Plymouth City Council

I.a. SPT17 25/26 - Kings Road Crossing

Decision	
1	Title of decision: 2137351 Kings Road – Pedestrian crossings, road humps and tree removal
2	Decision maker: Councillor John Stephens (Cabinet Member for Strategic Planning and Transport)
3	Report author and contact details: Mike Jones (Senior Traffic Engineer) E. trafficmanagementinbox@plymouth.gov.uk
4	<p>Decision to be taken:</p> <p>I. To install 2 Humped Zebra Crossings and an additional 7 Road Humps along Kings Road.</p> <p>Following consultation, it is proposed that the crossing nearest to the college be relocated further north to align with the position of the proposed pedestrian access into Foulston Park. This adjustment means that no trees will need to be removed to deliver the scheme in this area.</p> <p>The other crossing near Stonehouse Bridge will proceed as originally planned. An additional review into lighting requirements at the crossing has resulted in a revised proposal which removes the need for felling of the London Plane Tree, as advertised. The lighting requirement can be achieved by sensitive maintenance of the tree which could then be sustainably continued.</p> <p>The Road Humps to be

Drawing Title
KINGS ROAD ZEBRA CROSSING - NORTH

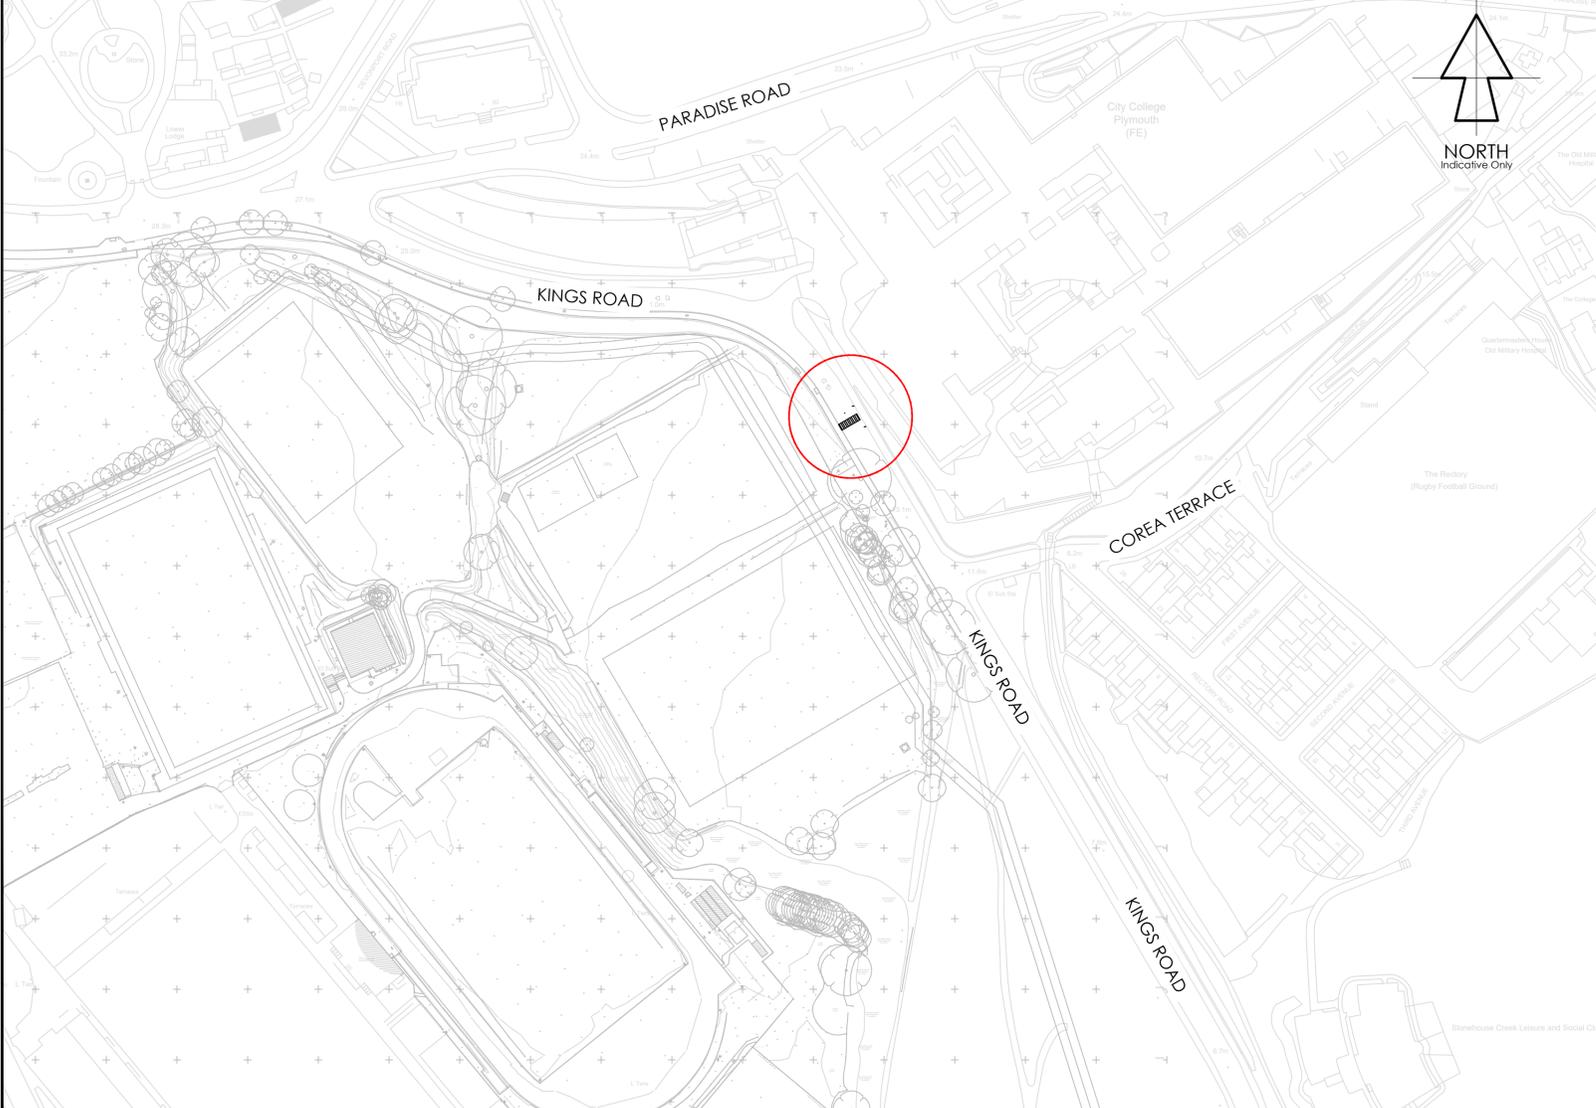
RSA Prob. No.	RSA Problem	RSA Recommendation	Design Organisation Response	Overseeing Organisation Response	Agreed RSA Action
3.	<p>Location: Kings Road at location of proposed northern zebra crossing</p> <p>Summary: Location of existing tree could compromise intervisibility between crossing westbound pedestrians and passing drivers and riders at the new northern zebra crossing on Kings Road leading to potential collisions</p> <p>The Audit team note the location of an existing tree in close proximity to the site of the proposed Zebra crossing on the northern section of Kings Road (see pic right). As such they are concerned that the tree could compromise intervisibility between passing drivers and riders and crossing westbound pedestrians, particularly in the growing season. This in turn could lead to heavy braking, shunt type collisions and the potential for collisions with crossing pedestrians. Additionally, the tree could compromise conspicuity of the proposed Belisha beacon at night which in turn could increase the potential for collisions at the crossing during the hours of darkness.</p>	<p><i>The potential for the existing tree to compromise intervisibility at the proposed new zebra crossing should be assessed and if found appropriate the tree should be adequately cut back or removed altogether.</i></p>	<p>Design team to assess location of existing tree in conjunction with Client.</p>

RSA Prob. No.	RSA Problem	RSA Recommendation	Design Organisation Response	Overseeing Organisation Response	Agreed RSA Action
4.	<p>Location: Kings Road at location of proposed northern zebra crossing</p> <p>Summary: The distance between the stop line and stud line on the drawing at the proposed zebra crossing could be too short allowing large vehicles such as buses and coaches to overhang the crossing area where they potentially intimidate or strike crossing pedestrians</p> <p><i>The Audit team are concerned that the distance between the stop line and the stud line on the drawing at the proposed zebra crossing could be too short. This could allow large vehicles such as buses and coaches travelling to and from PAFC to overhang the crossing area where they could potentially intimidate or strike crossing pedestrians.</i></p>	<p><i>Adequate distance should be provided between the stop line and the stud line at the proposed new northern zebra crossing on Kings Road in accordance with the appropriate standards.</i></p>	<p>Traffic Signs Manual – Chapter 6 – Traffic Control – Figure 16-2, states that the minimum distance from the edge of the crossing to the white lining must be 1100mm. Our design complies with this. Design to remain as proposed.</p>

RSA Prob. No.	RSA Problem	RSA Recommendation	Design Organisation Response	Overseeing Organisation Response	Agreed RSA Action
5.	<p>Location: Kings Road at location of proposed northern zebra crossing</p> <p>Summary: An existing gulley frame at the location of the proposed zebra crossing could be a heel trap to crossing pedestrians leading them to trip and fall into the path of oncoming vehicles</p> <p>The Audit team are concerned that an existing gulley frame could be in the crossing area of the new zebra crossing (see pic right). This could be a heel trap to crossing pedestrians leading them</p>	<p>If found appropriate the existing gulley frame on Kings Road should be relocated to the upstream side of the proposed new zebra crossing.</p>	<p>As the gully grating is already within a crossing and has a pedestrian friendly grating, it is proposed to retain this in its current location.</p>

Drawing Title
 KINGS ROAD ZEBRA CROSSING - SOUTH

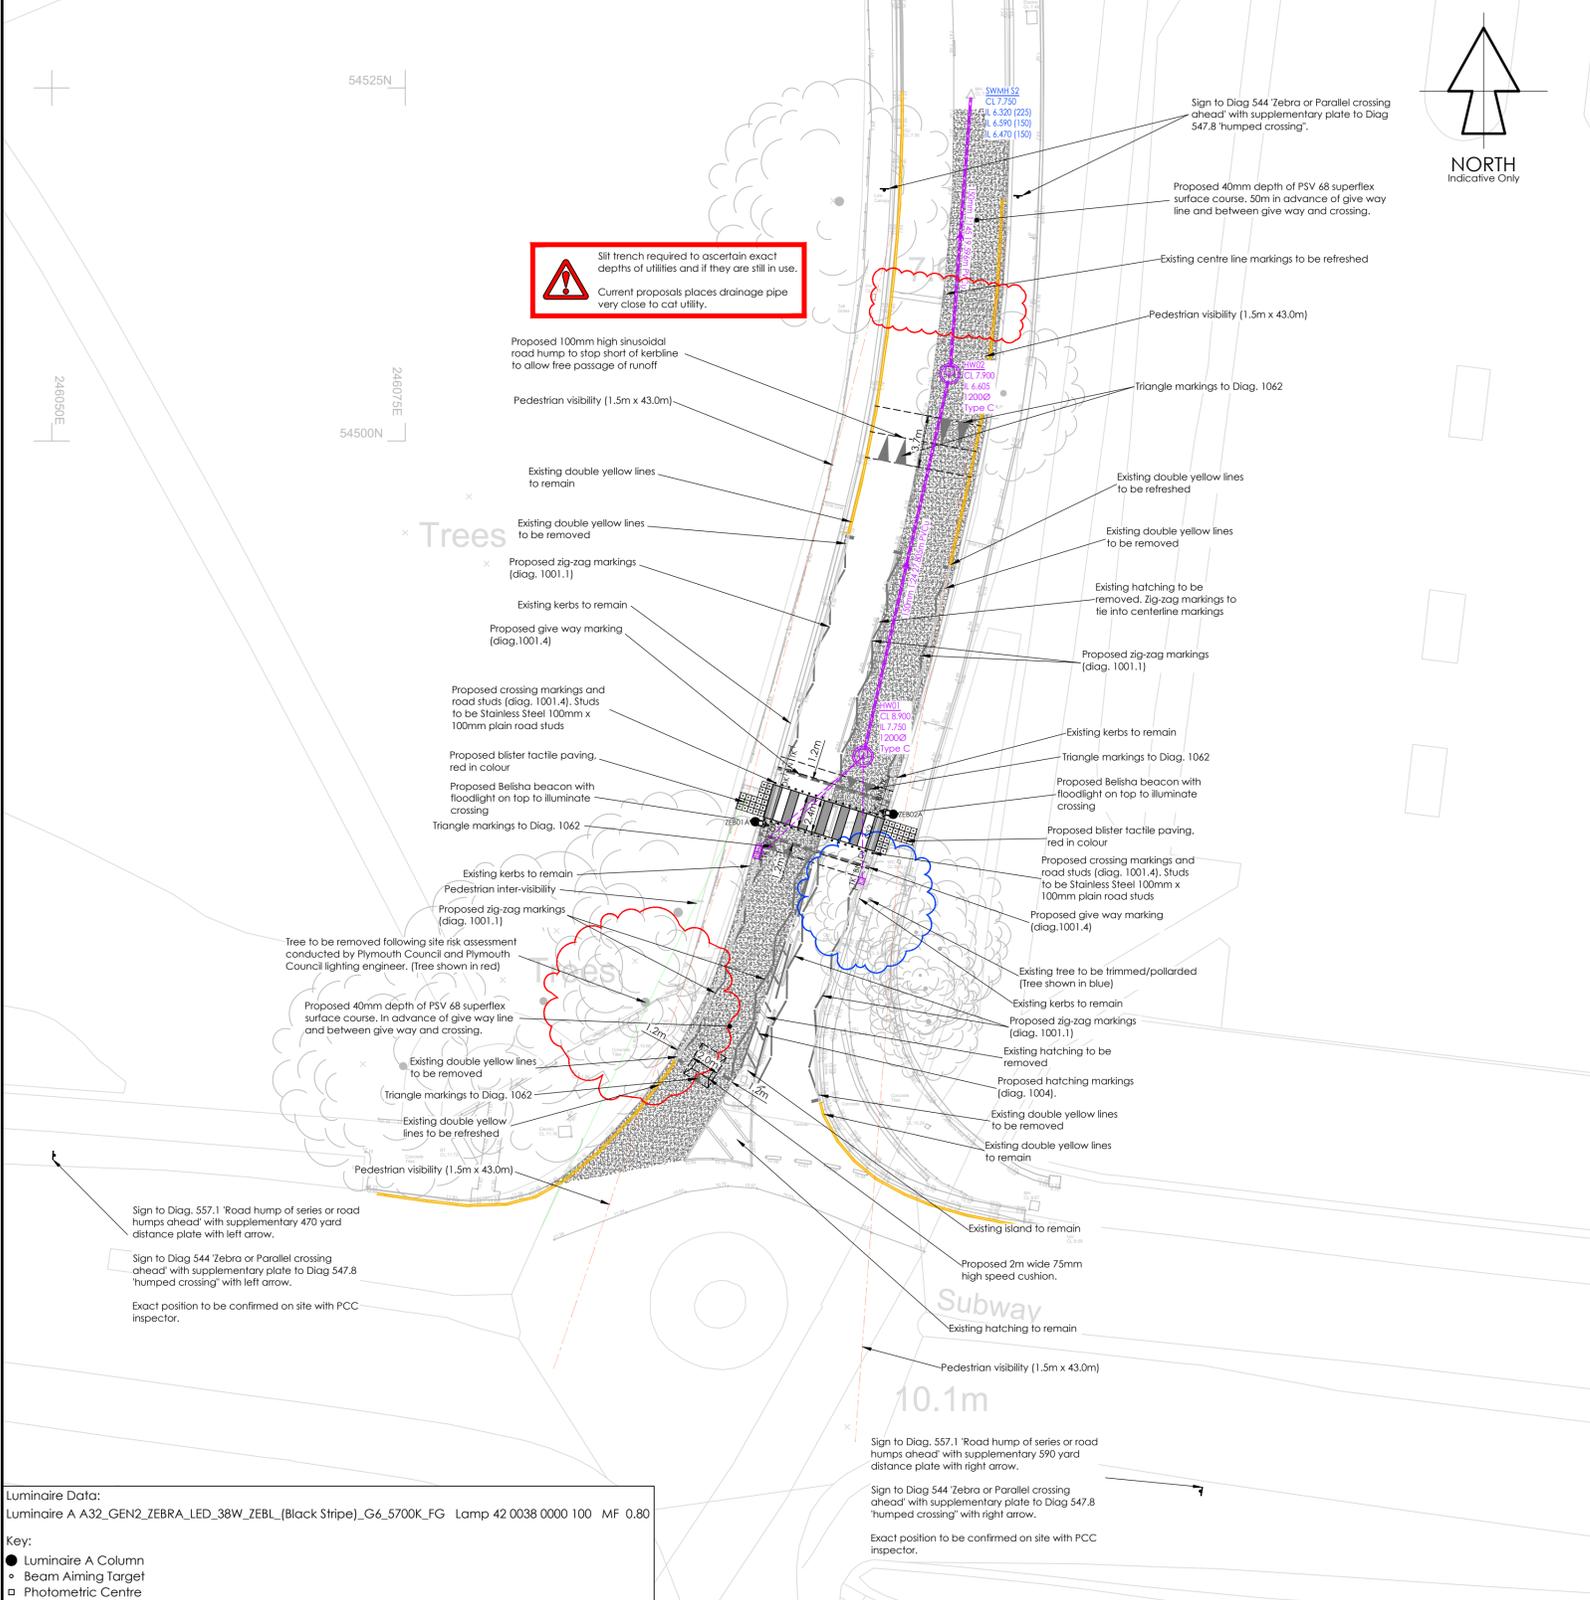
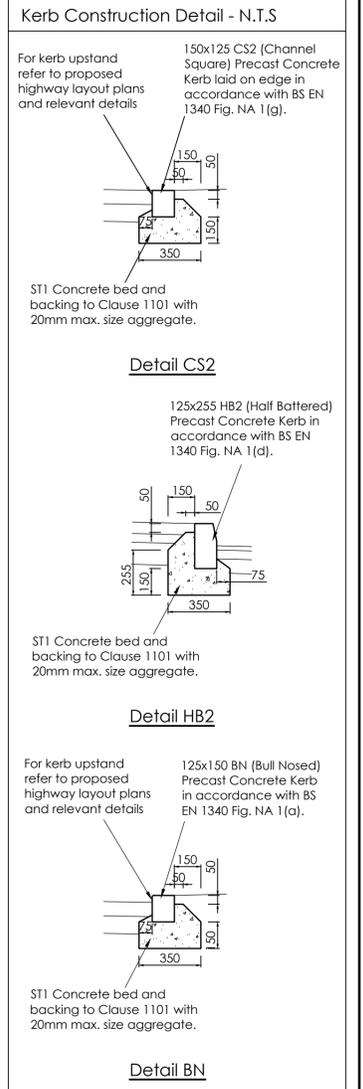
RSA Prob. No.	RSA Problem	RSA Recommendation	Design Organisation Response	Overseeing Organisation Response	Agreed RSA Action
6.	<p>Location: Kings Road at location of proposed southern zebra crossing</p> <p>Summary: The distance between the stop line and stud line on the drawing at the proposed zebra crossing could be too short allowing large vehicles such as buses and coaches to overhang the crossing area where they potentially intimidate or strike crossing pedestrians</p> <p><i>The Audit team are concerned that the distance between the stop line and the stud line on the drawing at the proposed zebra crossing could be too short. This could allow large vehicles such as buses and coaches travelling to and from PAFC to overhang the crossing area where they could potentially intimidate or strike crossing pedestrians.</i></p>	<p><i>Adequate distance should be provided between the stop line and the stud line at the proposed southern zebra crossing on Kings Road in accordance with the appropriate standards.</i></p>	<p>Traffic Signs Manual – Chapter 6 – Traffic Control – Figure 16-2, states that the minimum distance from the edge of the crossing to the white lining must be 1100mm. Our design complies with this. Design to remain as proposed.</p>

RSA Prob. No.	RSA Problem	RSA Recommendation	Design Organisation Response	Overseeing Organisation Response	Agreed RSA Action
7.	<p>Location: Kings Road at location of proposed southern zebra crossing</p> <p>Summary: Location of existing tree could compromise intervisibility between crossing westbound pedestrians and passing drivers and riders at the new northern zebra crossing on Kings Road leading to potential collisions</p> <p>The Audit team note the location of an existing tree in close proximity to the site of the proposed zebra crossing on the southern section of Kings Road (see pic right). As such they are concerned that the tree could compromise intervisibility between passing drivers and riders and crossing westbound pedestrians, particularly in the growing season. This in turn could lead to heavy braking, shunt type collisions and the potential for collisions with crossing pedestrians. Additionally, the tree could compromise conspicuity of the proposed Belisha beacon at night which in turn could increase the potential for collisions at the crossing during the hours of darkness.</p>	<p>The potential for the existing tree to compromise intervisibility at the proposed new zebra crossing should be assessed and if found appropriate, the tree should be adequately cut back or removed altogether.</p>	<p>Design team to assess location of existing tree in conjunction with Client.</p>

RSA Prob. No.	RSA Problem	RSA Recommendation	Design Organisation Response	Overseeing Organisation Response	Agreed RSA Action
8.	<p>Location: Kings Road at location of proposed southern zebra crossing</p> <p>Summary: The proposed length of high friction surfacing (HFS) on the northern approach to the proposed southern zebra crossing could be too short leading to heavy braking, shunts and collisions with crossing pedestrians</p> <p>The Audit team are concerned that the proposed length of HFS on the northern approach to the proposed southern zebra crossing could be too short in the prevailing 30mph speed limit for drivers and riders accelerating downhill away from the roundabout. This could lead to heavy braking, shunts and collisions with crossing pedestrians.</p>	<p>The length of HFS provided on the northern approach to the proposed southern crossing on Kings Road should be appropriate for the prevailing 30mph speed limit and if found necessary, the crossing should be relocated to achieve this.</p>	<p>CD 116 – Geometric design of roundabouts 8.2.4 states “Non-staggered controlled crossings should be sited either at 20 metres or more than 60 metres from the roundabout entry give way line. “. Meaning to fit the full 50m of High Friction Surfacing we would need to move the crossing a further 40m along Kings Road. This would result in people not using the crossing due to it being away from the desire line.</p>
